Access Compliance Report

Public Rights-of-Way

(Curb Ramps)

Intersection ID: 10022918	Main Street: CEDAR_CROFT_DR	Cross Street: N/A	Location: S
ADA ID: 4FC9F15B6381	Ramp Type: BlendTrans2	Initial Pass/Fail: Pass	Overall Compliance: No
		Severity Score: 0.25

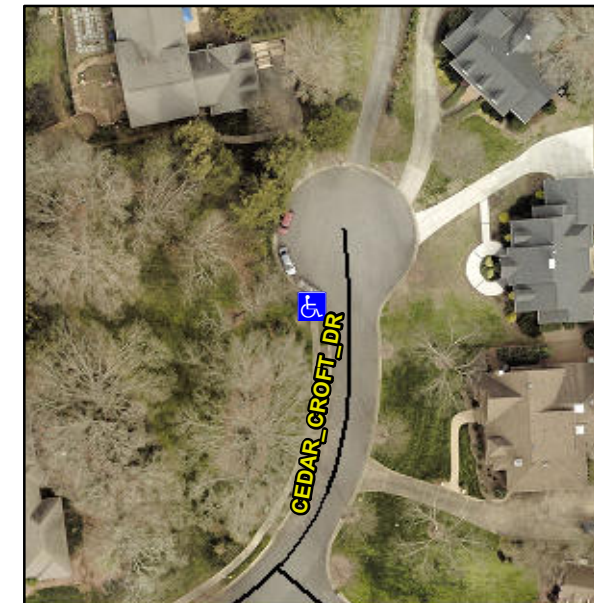
Surveyor Notes:

ASP LIP 0.5

PROW/ADA:

Not Found, R304.5.3, R304.2.3

Possible Solutions:

Remove & Replace Curb Ramp With Two New Directional Ramps or Equivalent.
